Product Information Notification

Product Group: OPT/Thursday March 13, 2025/PIN-OPT-1388-2025-REV-0

PCN OPT-1340-2024 - Addendum

PCN OPT-1340-2024 Package Dimensions Comparison

DIP-6

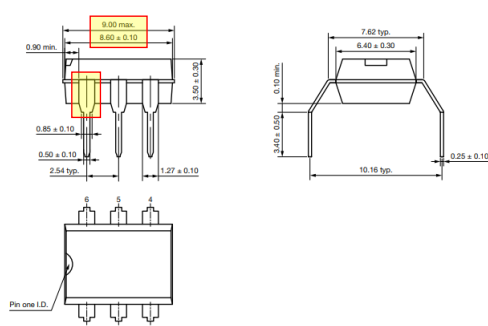
Note: major changes are the package length and the lead shape form

DIP-6, 400 mil (option 6)

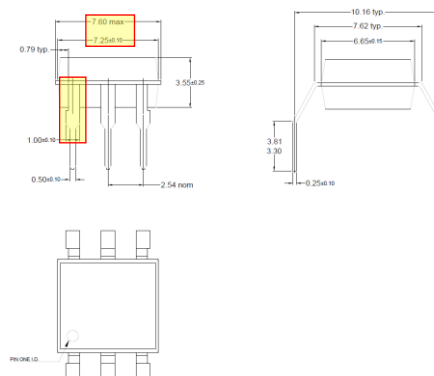
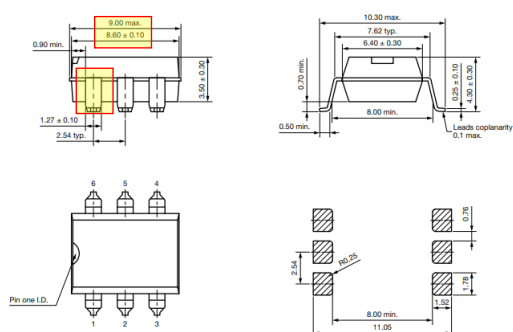
Note: major changes are the package length and the lead shape form

SMD-6 (option 7)

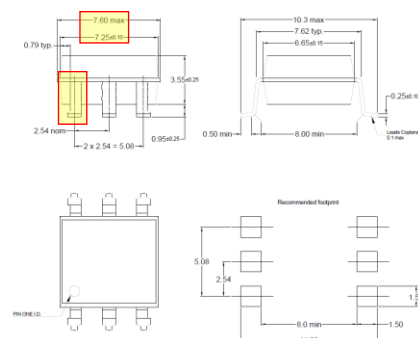
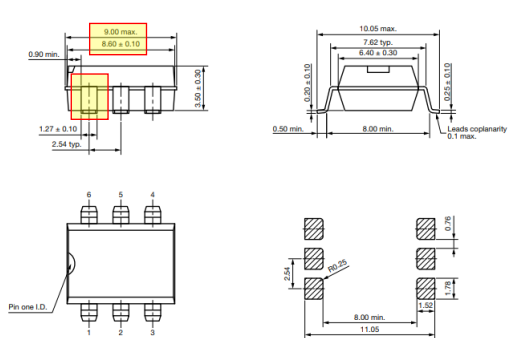
Note: major changes are the package length and the lead shape form

SMD-6 (option 9)

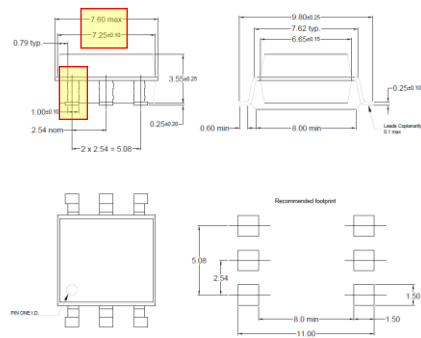
Note: major changes are the package length and the lead shape form
